Attachment 2 to AEP:NRC:0916I

PROPOSED TECHNICAL SPECIFICATION CHANGES

D. C. COOK - UNIT 2

FIGURE 2.1-1 Reactor Core Safety Limits -
Four Loops in Operation

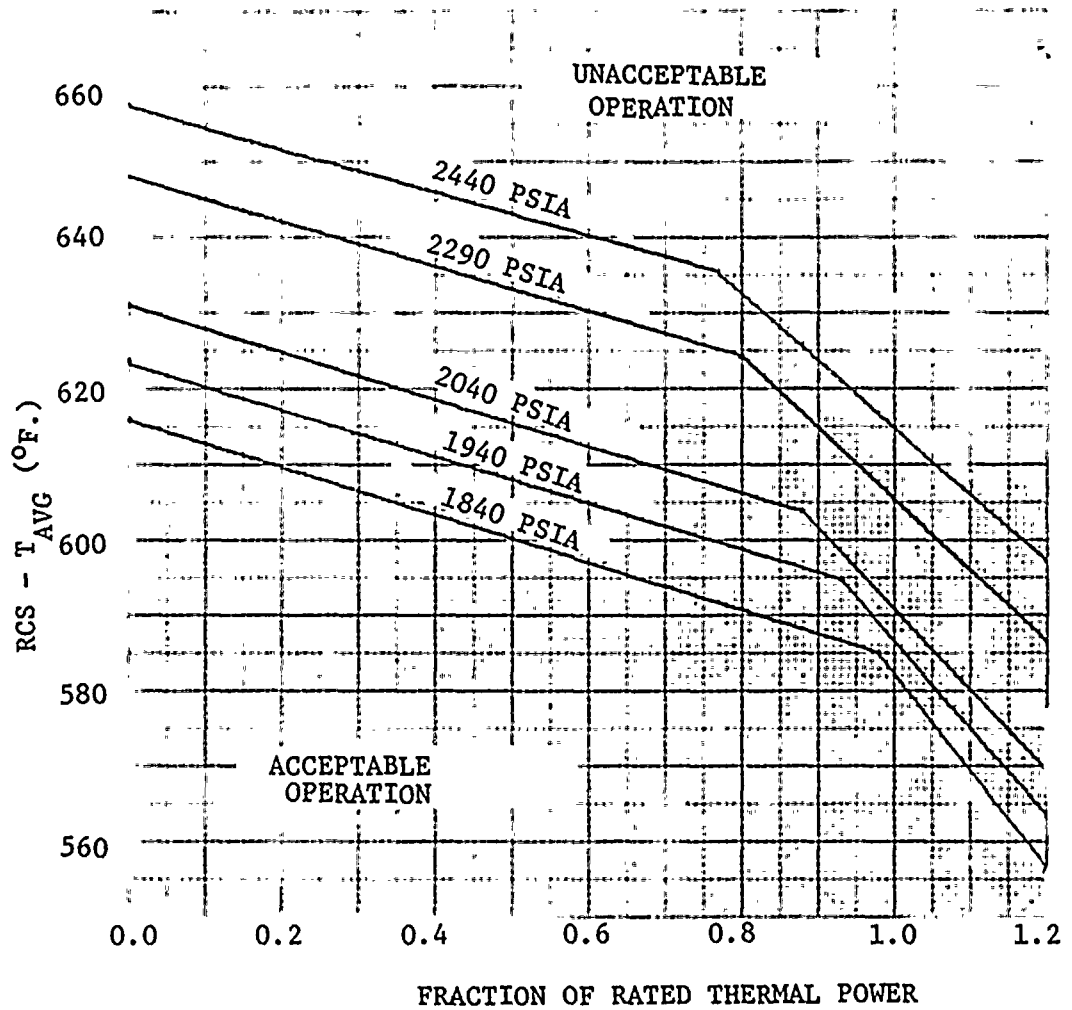
2.1.1 The combination of THERMAL POWER, pressurizer pressure, and the highest operating loop coolant temperature (T_{avg}) shall not exceed the limits shown in Figure 2.1-1 for 4 loop operation.

<u>PRESSURE (PSIA)</u>	<u>BREAKPOINTS (FRACTION RATED THERMAL POWER, T_{AVG} °F)</u>
1840	(0.00, 616.2), (0.98, 585.1), (1.20, 556.5)
1940	(0.00, 623.8), (0.93, 594.7), (1.20, 563.5)
2040	(0.00, 631.0), (0.88, 603.8), (1.20, 569.6)
2290	(0.00, 647.9), (0.80, 624.5), (1.20, 586.5)
2440	(0.00, 657.4), (0.77, 635.6), (1.20, 597.2)

FIGURE 3.2-2(a) D. C. COOK UNIT 2, $K(Z)$ - NORMALIZED $F_0(Z)$ AS A FUNCTION OF CORE HEIGHT FOR EXXON NUCLEAR CO. FUEL

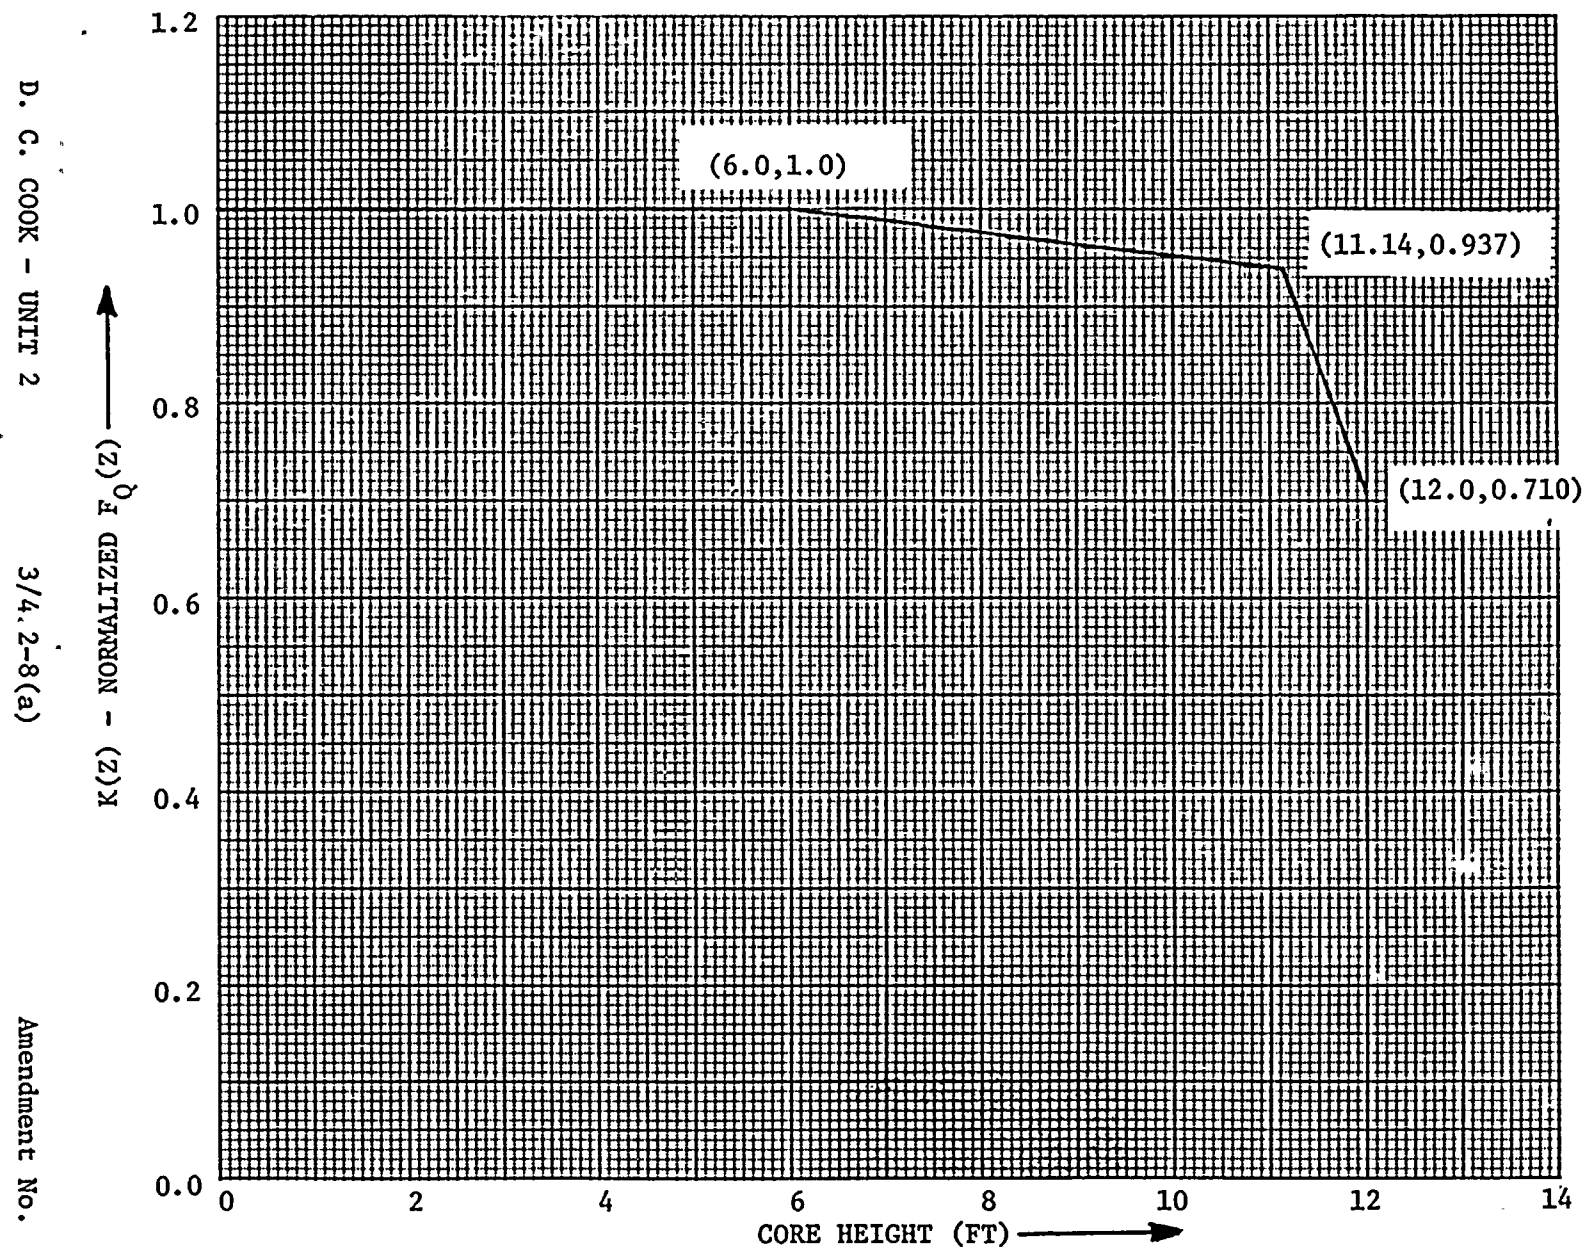
- $F_Q(Z)$ is the measured $F_Q(Z)$, including a 3% manufacturing tolerance uncertainty and a 5% measurement uncertainty.
- $K(Z)$ is the function obtained from Figure 3.2-2 for Westinghouse fuel and Figure 3.2-2(a) for Exxon Nuclear Company fuel.
